PROPOSED BUILDING PLANS OF
PHASE-VIII (PRIVANA-NORTH) FALLING UNDER
RESIDENTIAL COLONY
UNDER NEW INTEGRATED LICENSING POLICY(NILP)
DATED 11.05.2022 ON LAND MEASURING 116.29625
ACRES (LICENCE NO. 219 OF 2023 DATED 25-03-23)
(AN AREA MEASURING 103.09625 ACRES MIGRATION
FROM LICENCE NO. 27 OF 2012 DATED 02.04.2012
AND 13.24 ACRES AS FRESH AS FRESH APPLIED AREA)
IN SECTOR-78 & 77, GURUGRAM MANESAR URBAN
COMPLEX BEING DEVELOPED BY DLF LTD. IN
COLLABORATION WITH LAND OWNERS AND
IT'S ASSOCIATE COMPANIES

SURFACE PARKING AREA &
SITE PLAN FOR
SERVICES ONLY

ST-02

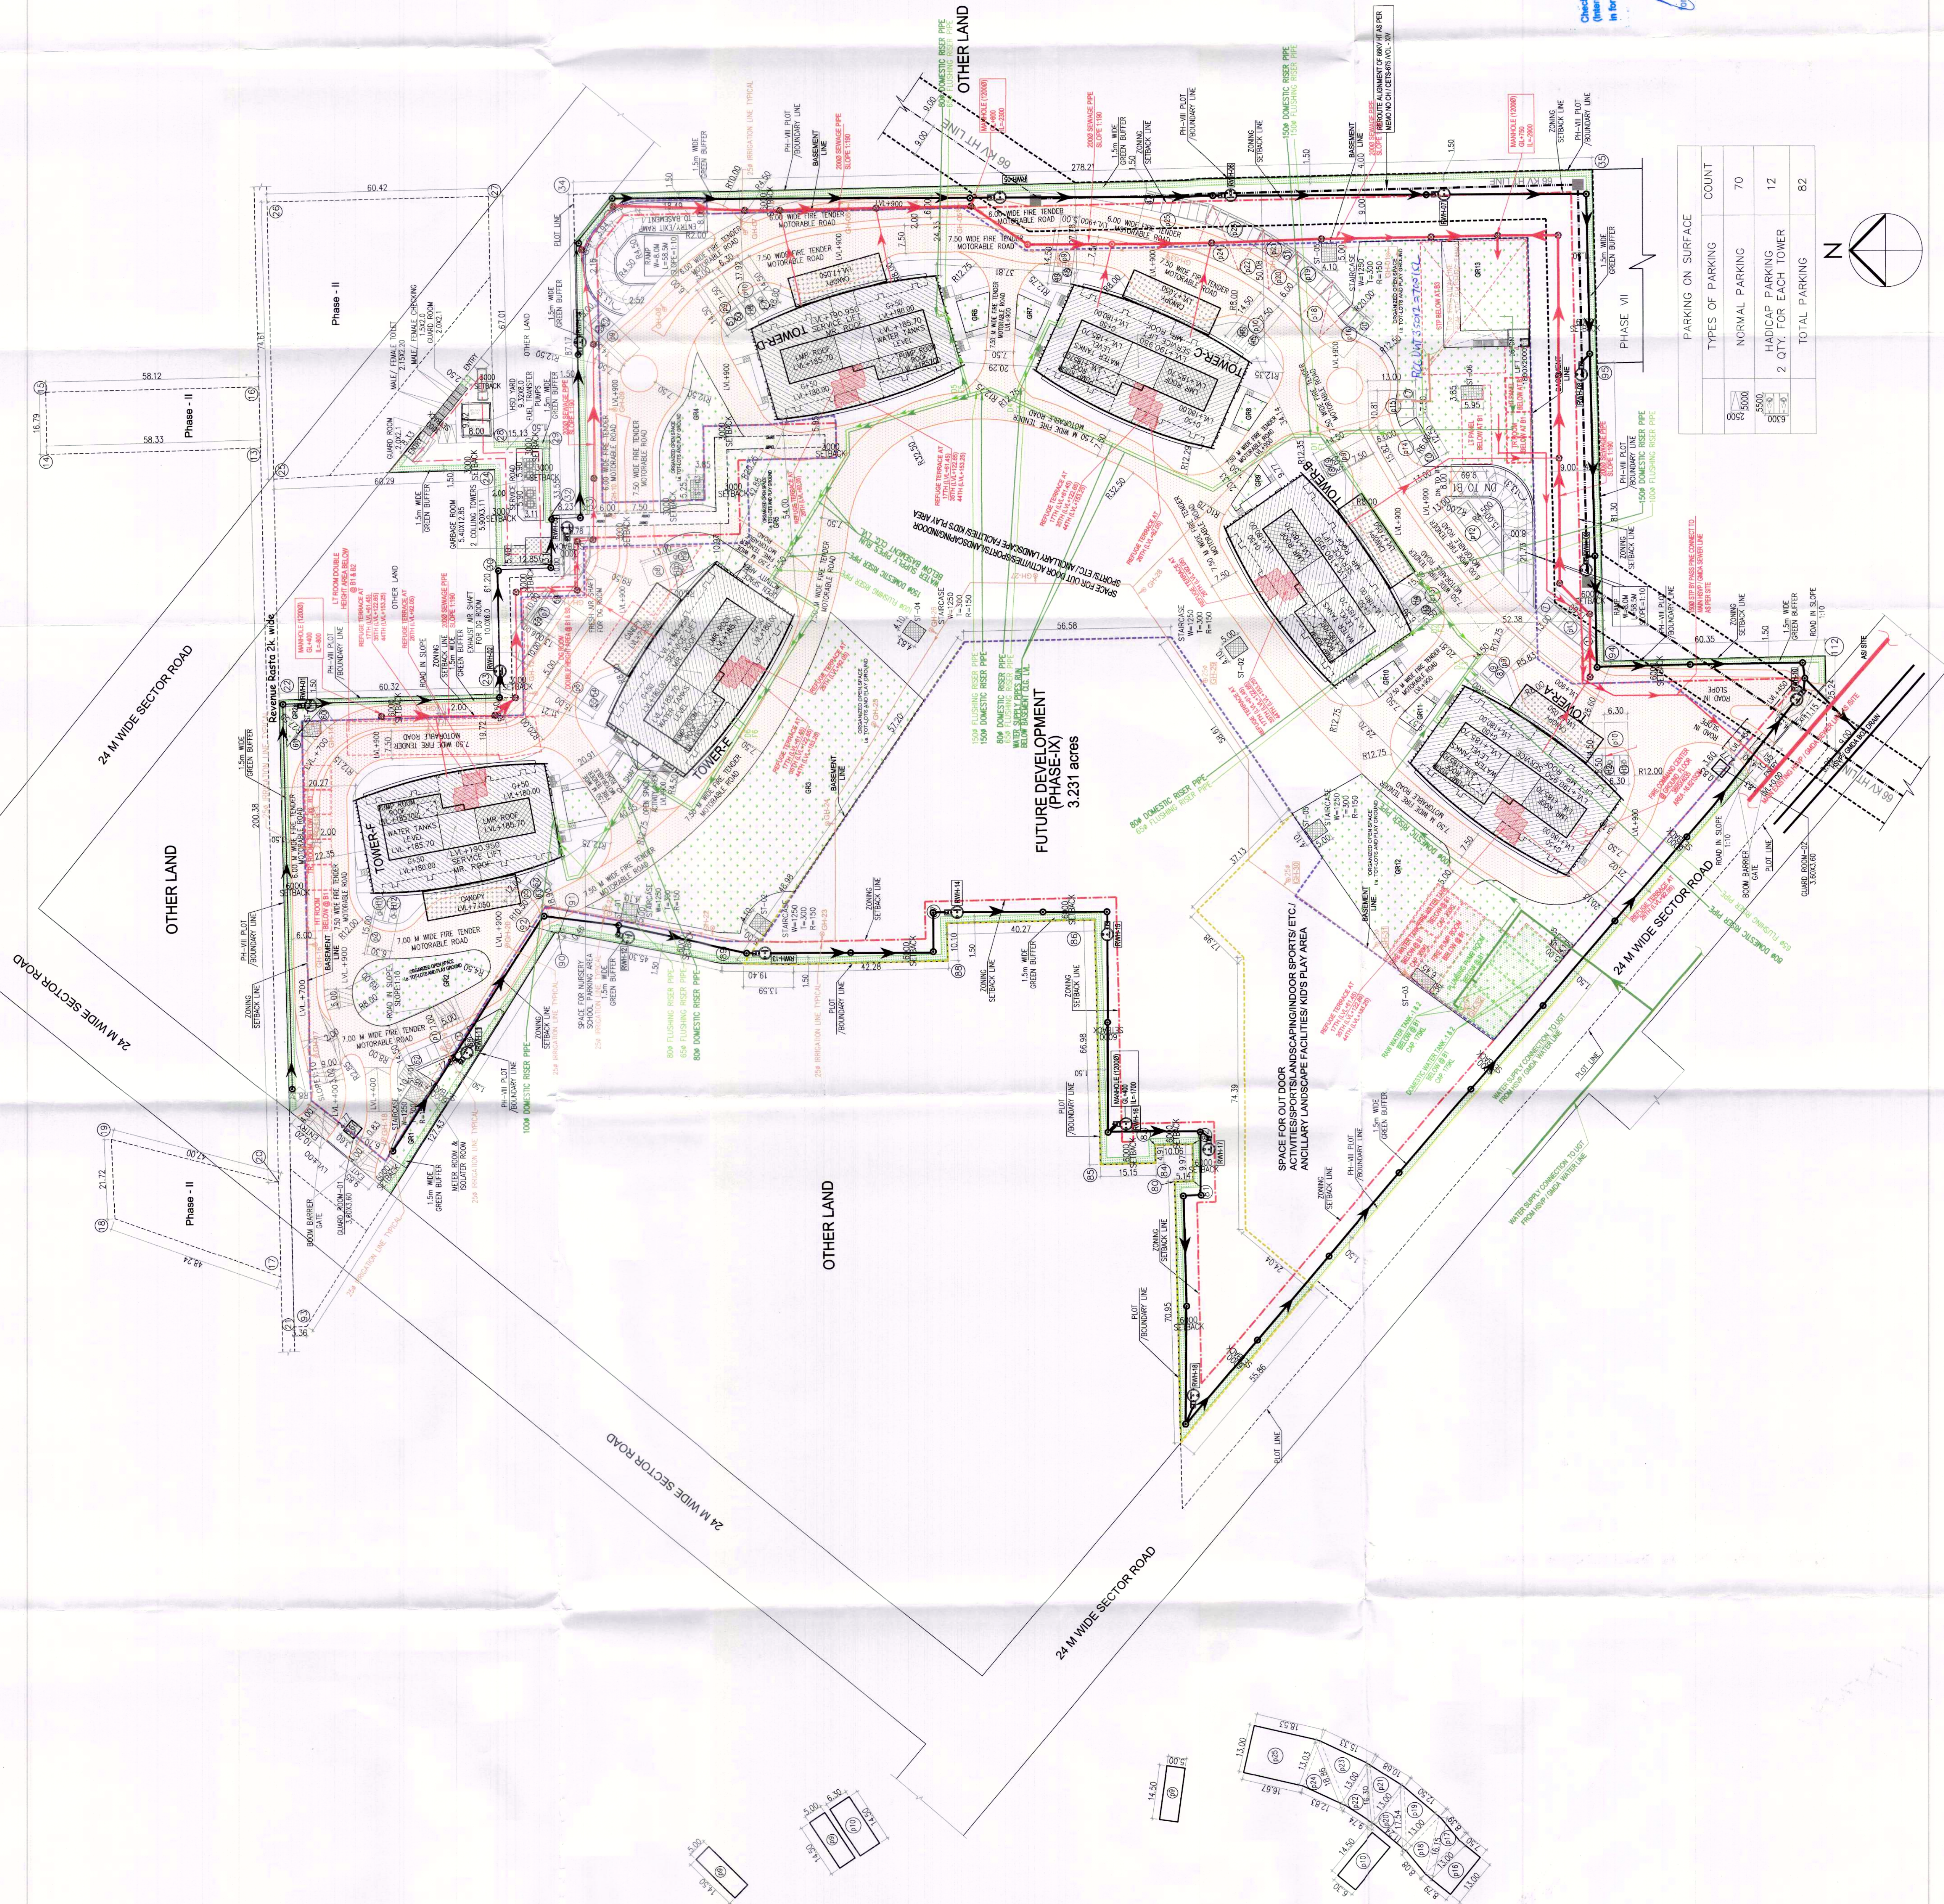
Checked and found ok for the health
(Internal) Sanitary and drainage comments in
the drawing No. 7.5.2.12, ON 02/03/23
